2 Type of change

- Change of product design

Product Change Notification					PCN TA36 Change of product design		
owner	creation date	release date	released by	change order	rev	page	D10-070-811
signergu	20.01.2023	08.02.2023	schulejo	2025494	A	1 of 2

3 Detailed description of change

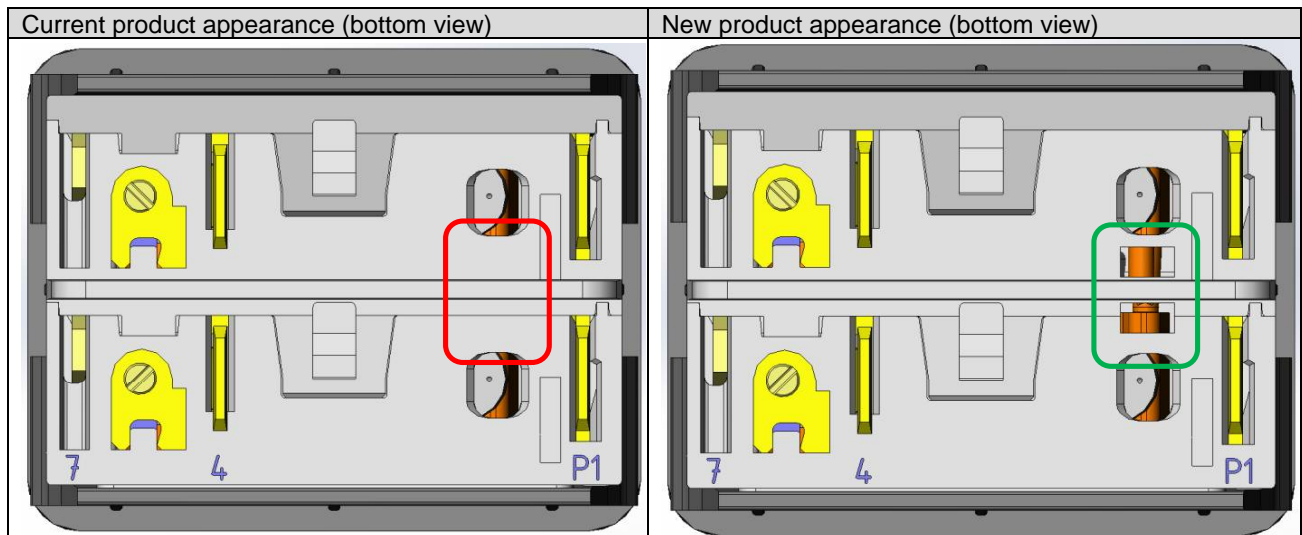
- Additional openings in the bottom of the housing
